MEMORANDUM FOR: Robert Johnson, Project Manager  
Salt Team, WMRP

SUBJECT: MAJOR SALT HYDROLOGY EA REVIEW COMMENTS; AND STATUS ON  
SALT HYDROLOGY EA REVIEW PLAN TASKS

DOMES  
INTRODUCTORY STATEMENT

<p>DEPTH OF MODELING AND OIL AND GAS POTENTIAL</p>	<p>NATIONAL WASTE TERMINAL STORAGE PROGRAM GEOLOGIC EVALUATION GULF COAST SALT DOMES LAW ENGINEERING RESEARCH COMPANY MEMPHIS, TENNESSEE</p>	<p>MISSISSIPPI BASH GEOLOGIC CROSS SECTION MIS NO. MV8799 FIGURE 3-1</p>
--	--	--

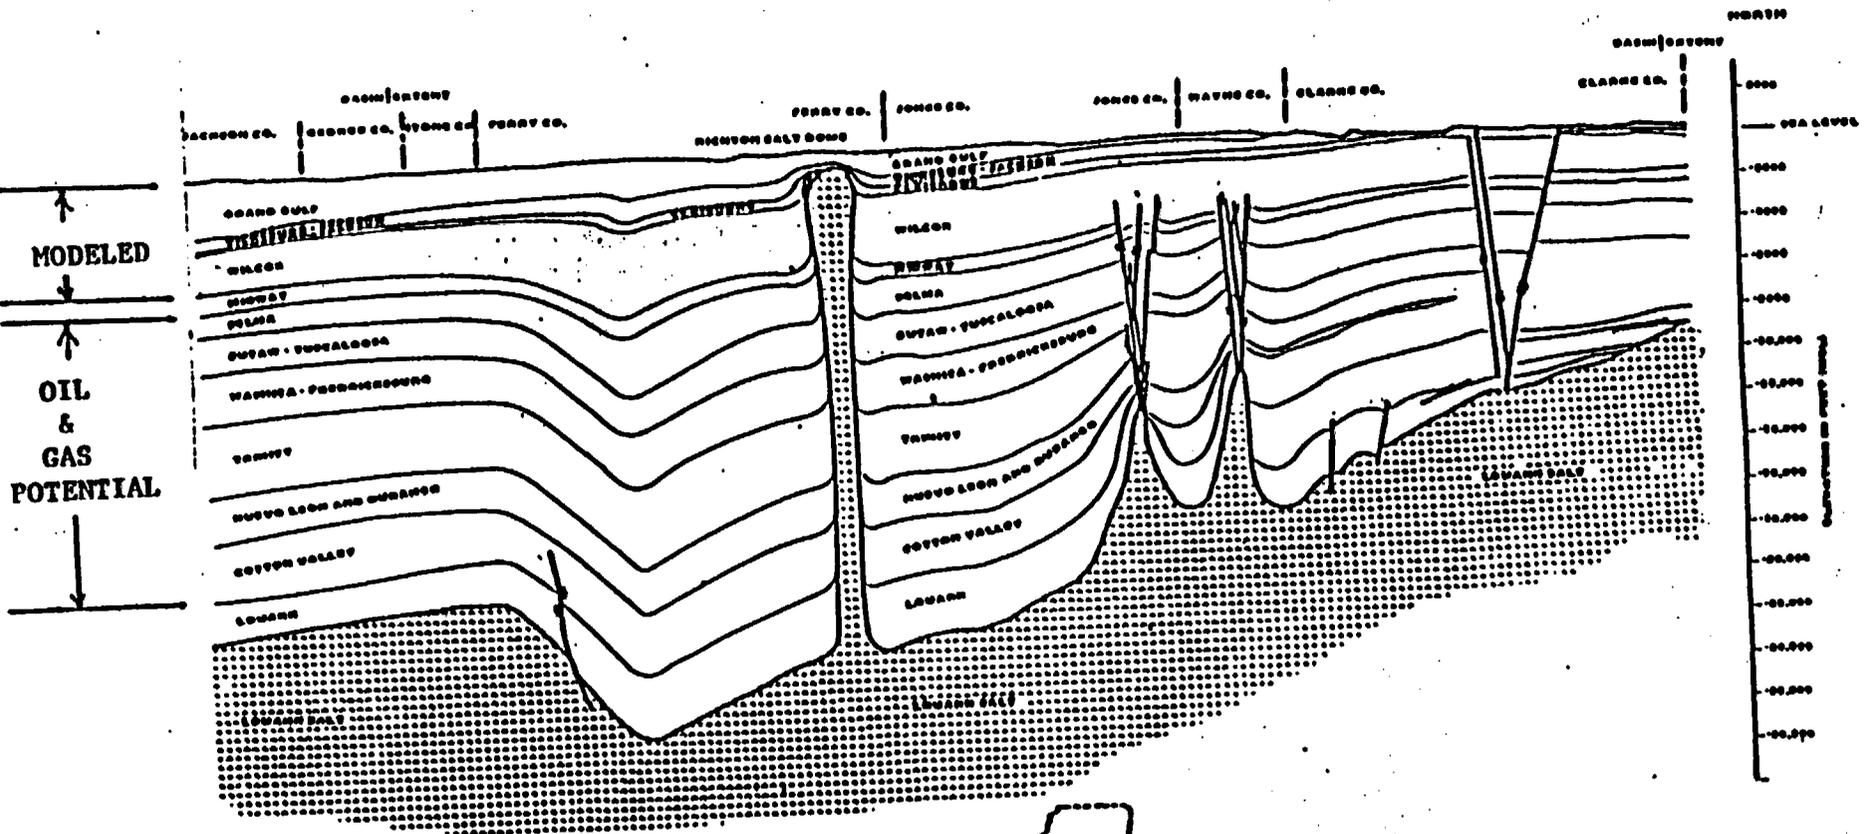
Cypress Creek repository will be placed at the Clairborne Formation horizon, which is above the Wilcox Formation. The Environmental Assessment (Draft 4) states that groundwater flow was modeled down to the Wilcox Formation. However no deeper units were included in the modeling, even though deeper units could also be pathways to the accessible environment from oil and gas production. This is particularly true for Cypress Creek Dome, which has an oil and gas field in on its flanks. The importance of this observation is that the model does not consider all alternative pathways. The resolution is to explain why deeper units do not have to be considered or to model deeper units.
